<b>CHANGE REQUEST NO. ILC-CR-XXX</b>	EDMS No: <b>D*xxxxxxx</b>	Created: <b>01-30-2017</b>
		Last modified: <b>02-20-2017</b>

## **KAMABOKO-SHAPED POSITRON BDS TUNNEL**

Fig. 1: Schematic figures of (a) the TDR and the proposed positron BDS tunnel layout and (b) the proposed configuration.

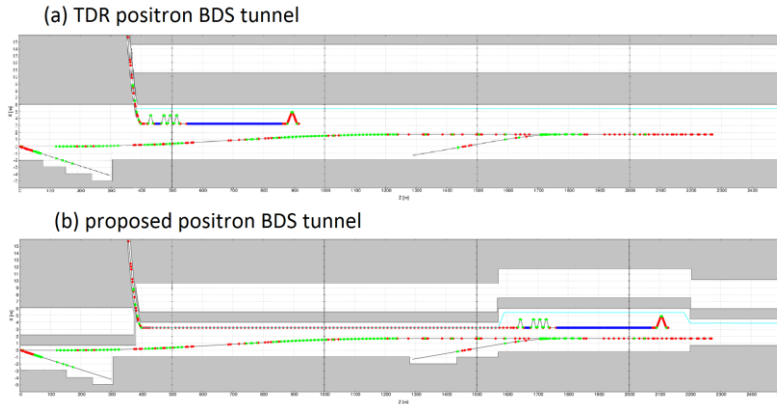
Figure 1 shows the schematic drawing of the TDR and the proposed positron BDS tunnel. The TDR BDS tunnel is designed as a twin tunnel between ML to LTR, and as a single tunnel between LTR to detector

hall. In this proposal the positron BDS tunnel is Kamaboko-shaped tunnel all along the positron BPM beamline. Furthermore, the electron source is relocated to upstream of the positron BDS tunnel.

Fig. 2: Schematic figures of the tunnel cross section of (a) TDR and (b) proposed positron BDS tunnel layout.

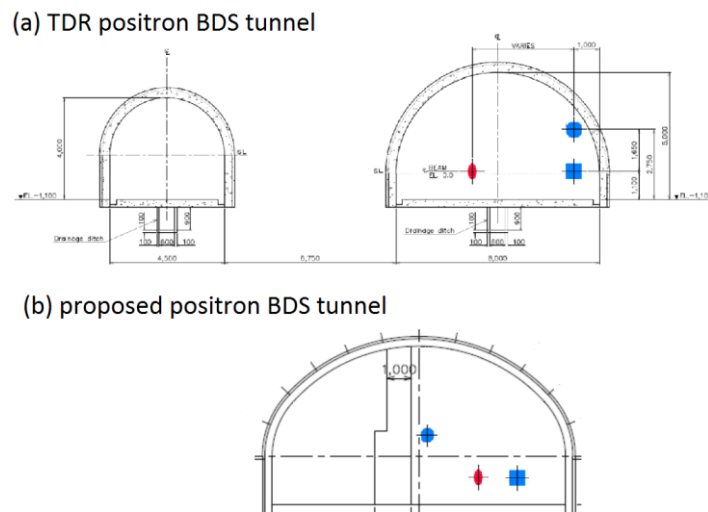
Since the service and the accelerator tunnels are separated by 6.75m thickness hard-rock material in TDR tunnel configuration, it is difficult to drill the waveguide and cable penetrations between the tunnels, and the penetration costs are expected to be expensive. However, it is easy to make the penetrations in Kamaboko tunnel (see Fig.2). The shield wall will be 1.5 meters under the same condition as for the ML (i.e., no human access during beam operation).

Fig. 3: Schematic figure of the high voltage power line distribution from the utility hall in the central region to the main linac tunnel.

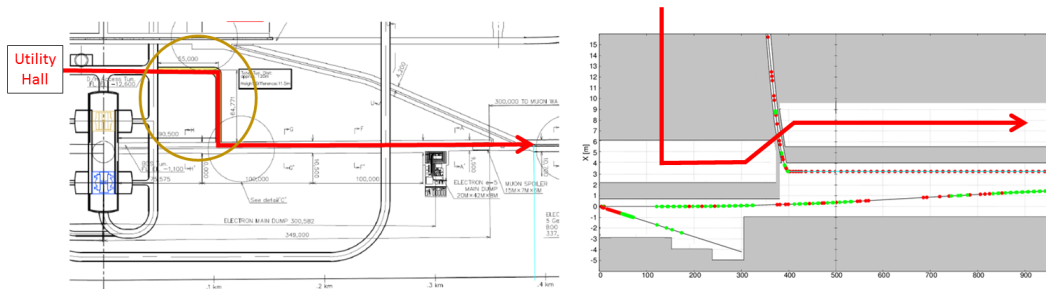
The main high voltage AC power line (66kV) will be distributed all along the LC tunnel. By making the service tunnel along the BDS beamline all the way from LTR to the detector hall, the high voltage power line can be distributed in the service tunnel. Especially when the main electrical station is located at the utility hall in the central region, the service tunnel is useful to distribute the high voltage power line to main linac tunnel (see Fig.3).

Fig. 4: Schematic figure of the helium transfer paths.

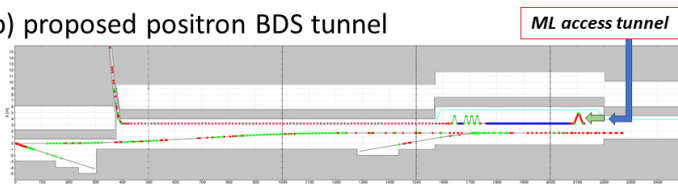
There is a Helium cold box and a compressor in the ML access tunnel for main linac cryomodules. When the electron source will be relocated to upstream, the distance in between the electron booster linac to ML access tunnel will be shortened. Therefore, we can use the facilities of main linac cryomodules with shorter Helium transfer line (see Fig.4). The relocation of the electron booster will make longer the 5GeV electron transfer line from the source to the damping ring, but this disadvantage will be minor compared with the helium transfer line. Also, the relocation has a benefit that the radiation from the collimator would not make shower on the cryomodules.
